**EGG-SSRE-9926
November 12, 1991**

**EVALUATION OF EPRI DRAFT
REPORT NP-7065 - REVIEW
OF NRC/INEL GATE VALVE
TEST PROGRAM**

**Prepared for the
U.S. NUCLEAR REGULATORY COMMISSION**

**Robert Steele, Jr.
John C. Watkins
Kevin G. DeWall**

FIGURE 2-7

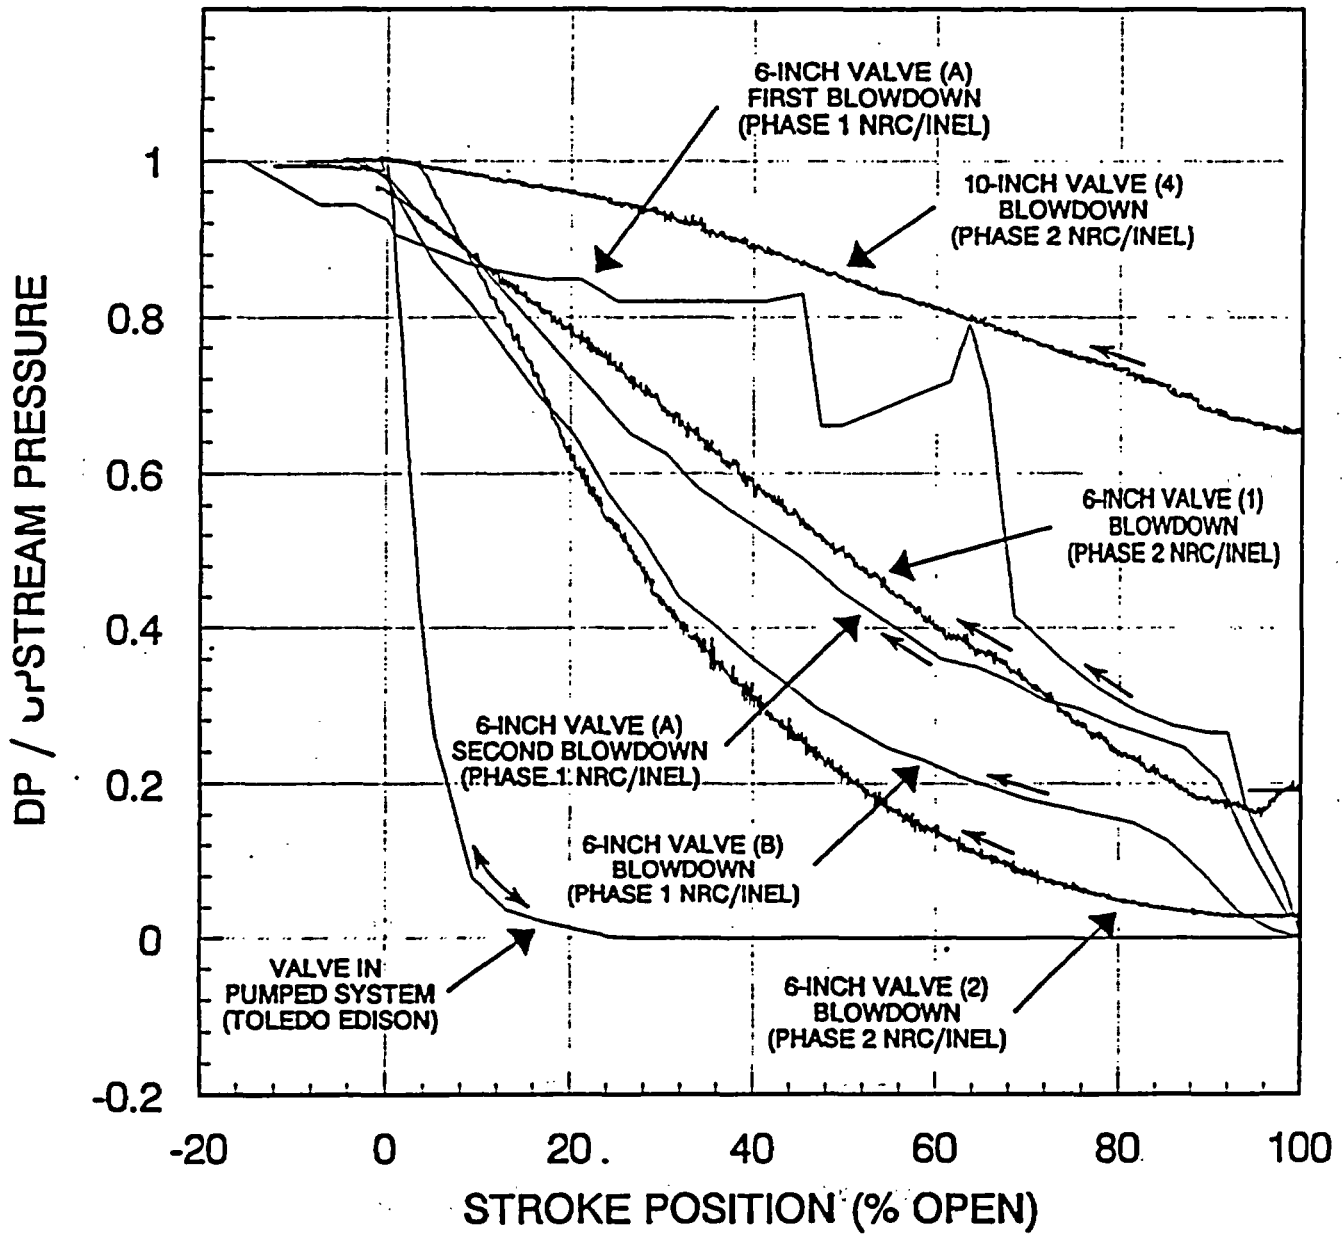
3. Blowdown conditions for 6-inch valves, even when tested in the same loop, showed considerable differences. For example, Valves 1 and 2 showed significantly different behavior during mid-stroke (Figure 2-7). Although some of this behavior may be attributable to valve flow resistance differences, it appears more likely there were differences in the way the test facility operated. Valve 3, although not shown, started off with a DP

Figure 2-7 in the EPRI report actually shows that without a significant loss in upstream pressure, Valves 1 (A) and 2 (B) show different but very reproducible behavior between Phases I and II. Note how the Valve 1 and A traces lie almost on top of one another. The same is true for Valve 2 and B. Recall that Phase I and II used different test facilities with completely different piping configurations. The EPRI report's argument for a difference in how the facilities operated as the cause of the

FIGURE 2-8

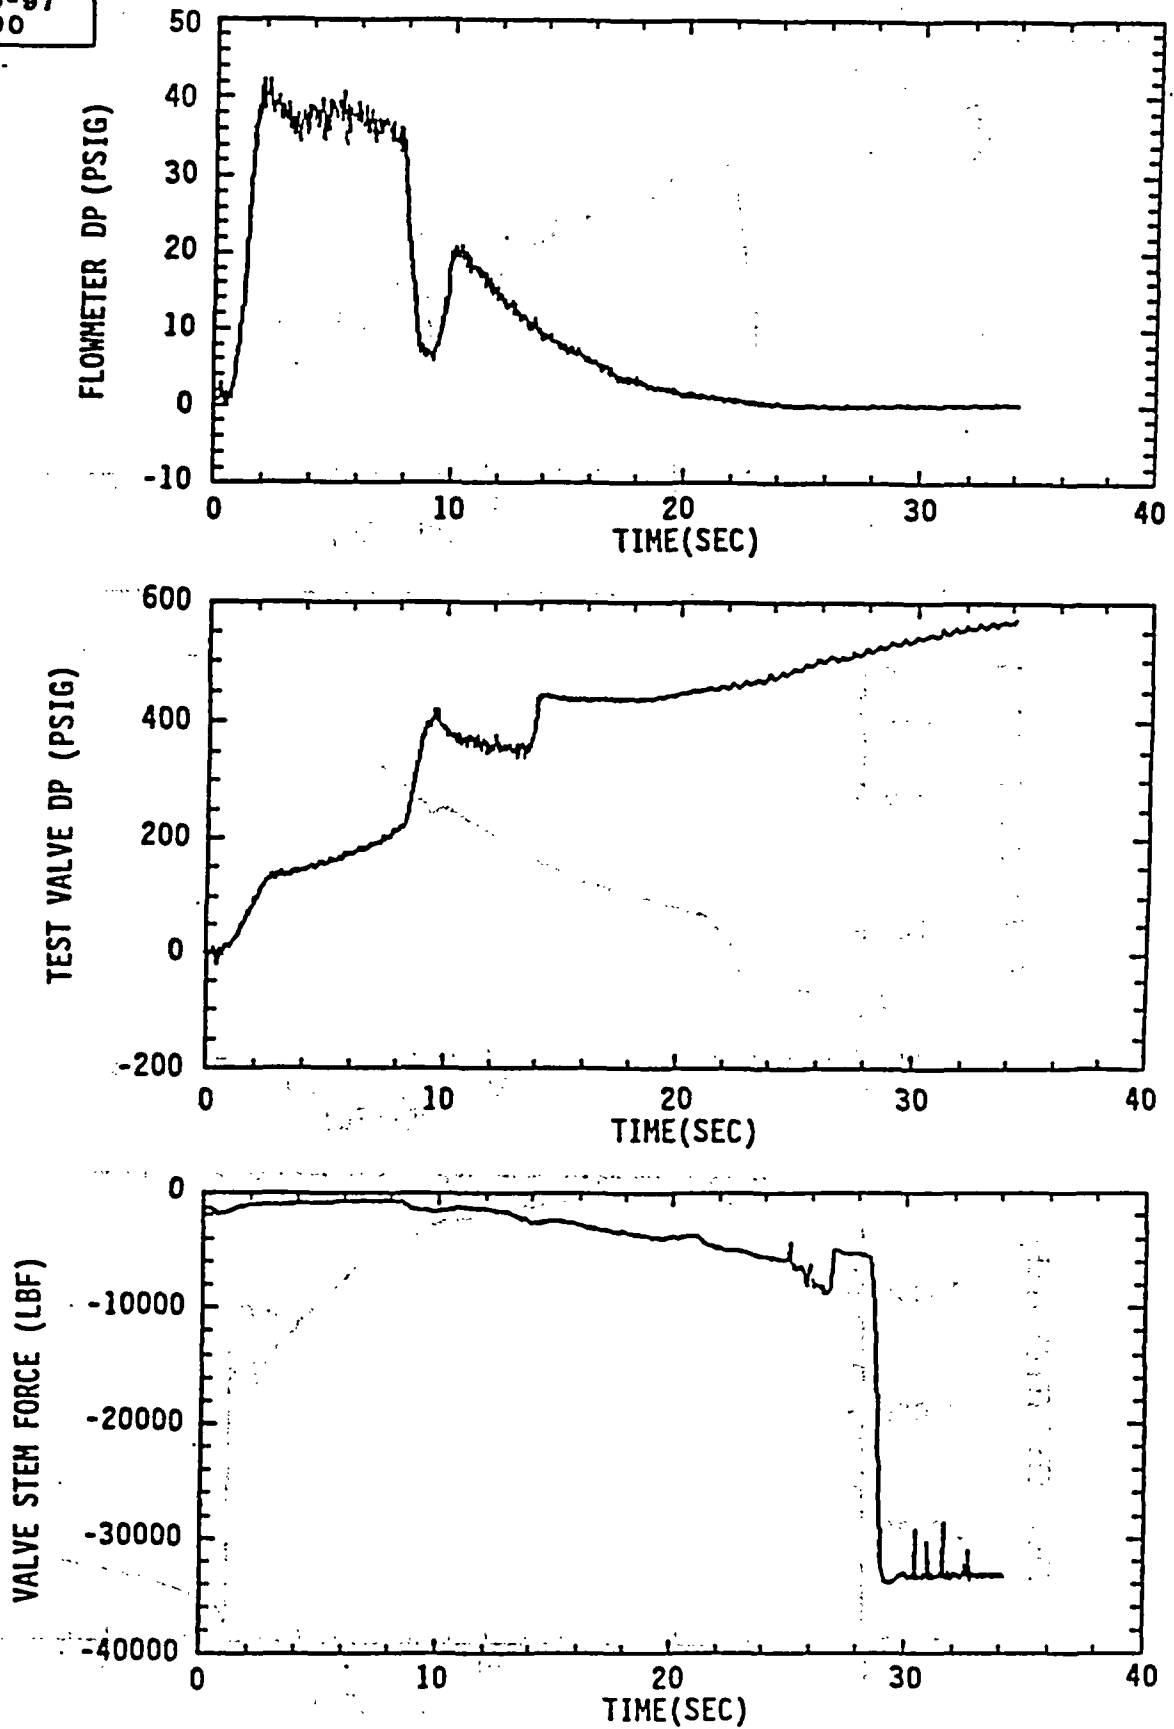
A complete transition from water to nitrogen flow appeared to occur on the first blowdown stroke of Valve A (Test 3 Step 5). Figure 2-8 shows the DP across the upstream flowmeter and across the test valve. At a time of about 8 seconds, the flowmeter DP drops sharply. After about one second, it rises again. If a water/nitrogen interface passed through the system, the flowmeter at the upstream end of the system would first show a sharp drop as the fluid density dropped. Then, as the water slug in the system was accelerated and ejected from the system, the DP would increase, first gradually (during acceleration) and then sharply (at ejection). This behavior is seen on the flowmeter DP plot in Figure 2-8. At the test valve location, which is further downstream, DP would be expected to increase as the water slug was accelerated, drop as the nitrogen arrived at the valve and then increase as the slug cleared. This is consistent with the observed behavior, although the times are not as sharply defined. This could be due to a blending of nitrogen and water as it flowed downstream. Nonetheless, it appears that after about 10 to 14 seconds, when the valve was about 30-45% closed, only nitrogen was flowing through the valve. The valve stem force plot, also shown in Figure 2-8, shows that substantial forces developed only in the last one-half of the valve stroke, i.e., when nitrogen flow was occurring.

also that there is nothing in the EPRI reports' Figure 2-8 to indicate that nitrogen entrainment had any effect on the measured stem force.

**STEM FORCE HISTORY FOR
VALVE 2 BLOWDOWN CLOSURE
FIGURE 6-4**

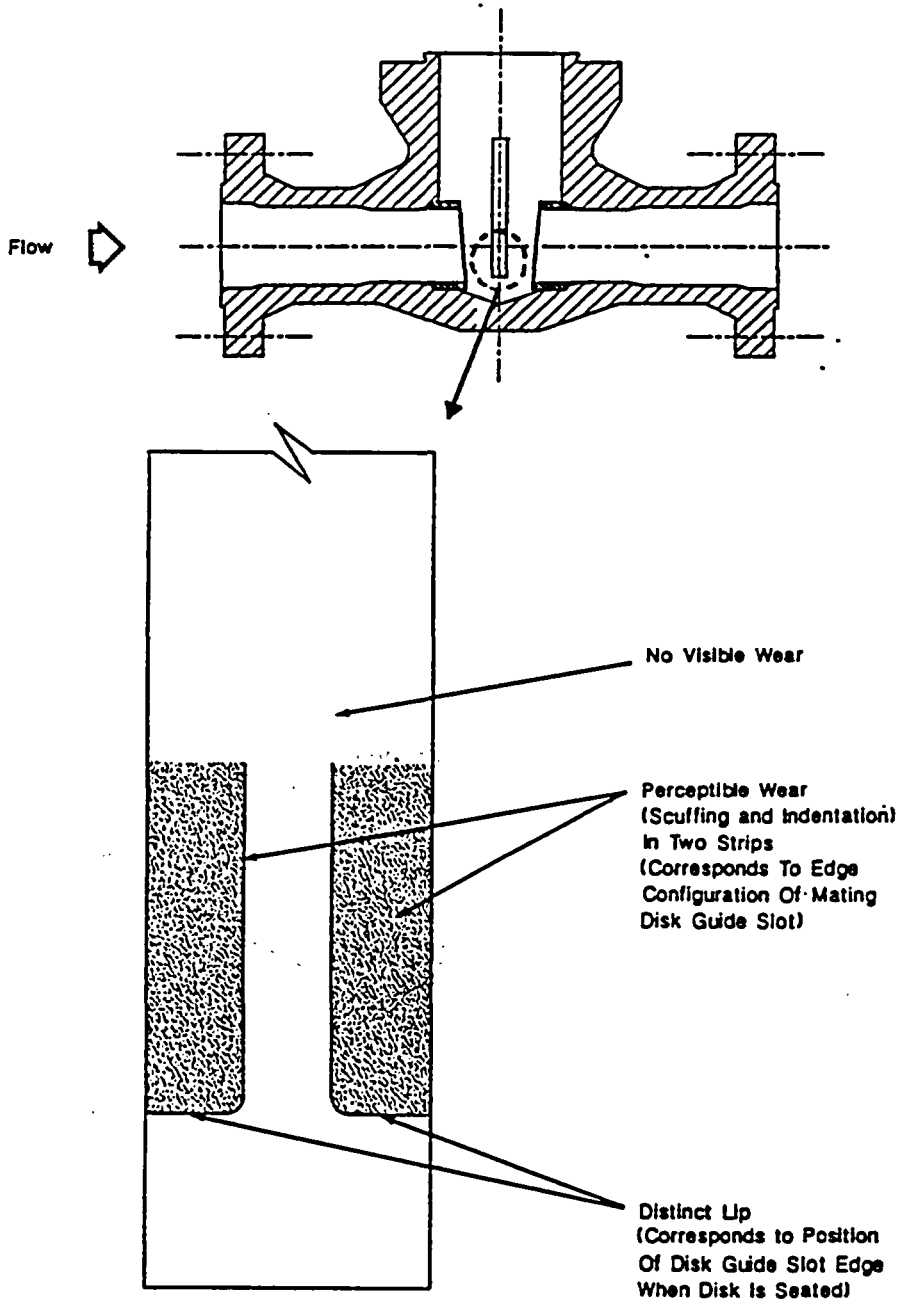
However, as shown in Figure 6-4 and Table 6-1 of the EPRI report, the apparent disc factor for Valve 2 during Step 25 of Test 6B was calculated with a stem force (13,000 lb,) that was on the *"essentially vertical section of the stem force plot,"* not just prior to it. While using a stem force on the vertical section will yield a higher (and thus a more conservative) apparent disc factor, we are more concerned with the care used in assessing the INEL test results. We have not determined whether this type of error occurred for any of the other wedging positions assessed in Table 6-1 of the EPRI report.
